AGENDA SECTION: PUBLIC HEARINGS	ORIGINATING DEPT: PLANNING	ITEM NO. <b>E-4</b>
ITEM DESCRIPTION: General Development Plan(GDP) #219, to be known as Spring Brook Valley. The GDP includes a total of approximately 112 acres of land and proposes to develop the eastern 17.16 acres in the B-4 (General Commercial) district, with the western 94.14 acres developed in the R-1x (Mixed Single Family Extra) district. The Plan also identifies public and private roads, stormwater ponds, public parkland and accesses to the TH 63 Frontage Road. The property is located west of TH 63, south of TH 52 and Southtown Heights and north of 36 <sup>th</sup> ST. CWA		PREPARED BY: Mitzi A. Baker, Senior Planner

**RE:** General Development Plan #219 to be known as Spring Brook Valley.

### Planning Department Review:

PLAN 12-22-03

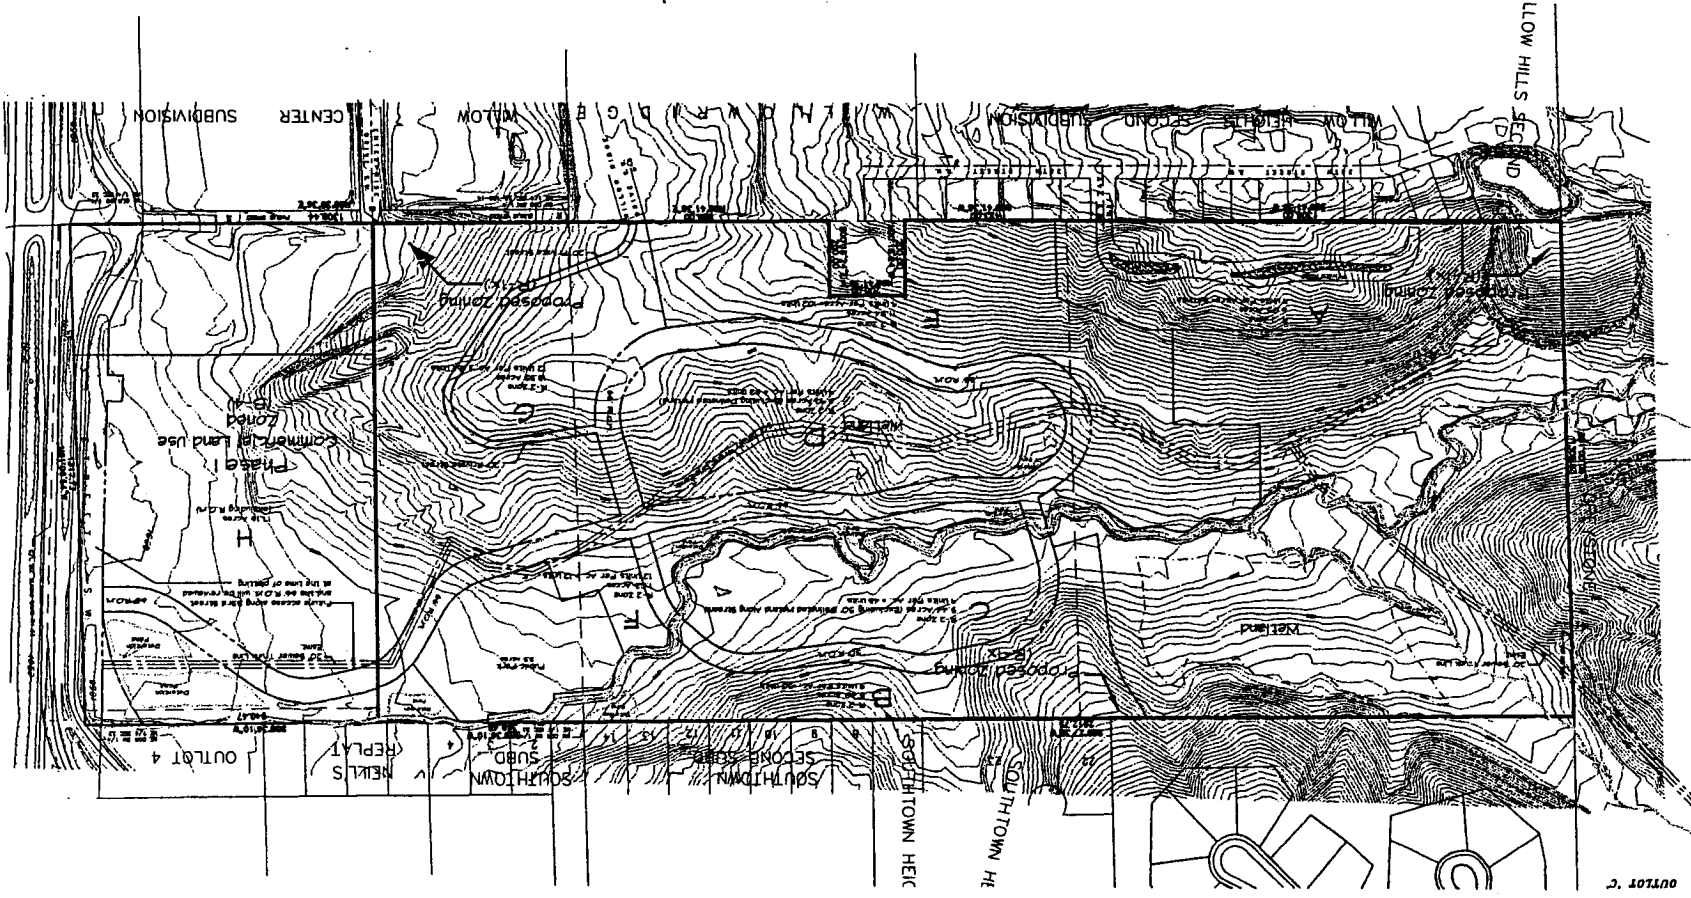
Please note: Staff recommends that Enterprise Drive be extended into this development. If the Council agrees with this recommendation, the GDP should be denied as proposed. The GDP does not accommodate extending this right-of-way.

- 3. Right of Way for Enterprise Drive terminates at the south line of this property and is not currently shown to extend into this GDP. This Right-of-Way should be extended into this property and incorporated into the roadway network for this Site.*

Right-of-way for Enterprise Drive SW is platted to the south property line of this GDP, but is not proposed to be extended into the property. Extension of this roadway should be included in this GDP.

***Currently, Enterprise Drive right-of-way terminates at the south line of this development. The GDP submitted does not include an extension of Enterprise Drive. As recommended by Rochester Public Works, the extension of this roadway needs to be incorporated into this GDP.***

*Enterprise Drive should be extended north into this property to provide additional access and circulation. The application currently does not accommodate the extension of this roadway. It's difficult to approve a GDP with a condition that the roadway is extended into the site, because there is no opportunity to review the proposed alignment and other changes that would occur in the GDP to accommodate the extension. If the Commission and Council agree that this roadway should be extended into this GDP, the GDP should probably be denied for failure to accommodate.*

Figure 4: Half Closure

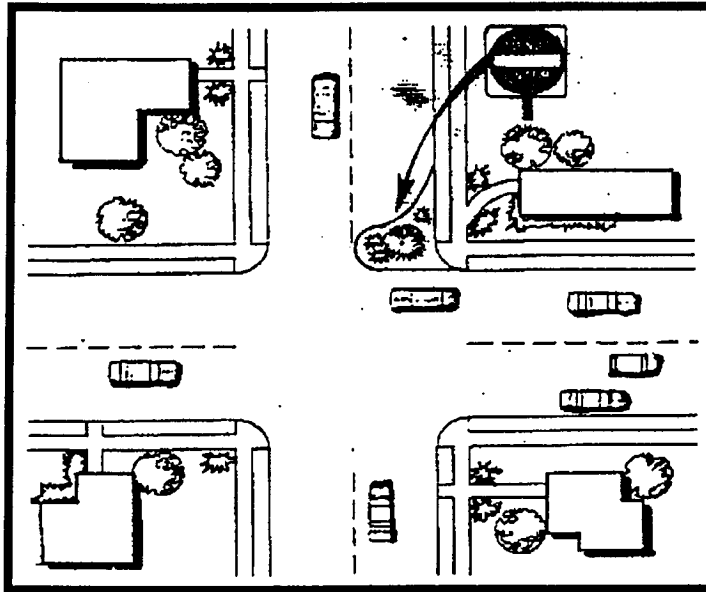
1. A second alternative is to consider some traffic calming options on the extension of Willow Ridge Drive. One option as illustrated in figure 4 would permits only inbound/northbound traffic.
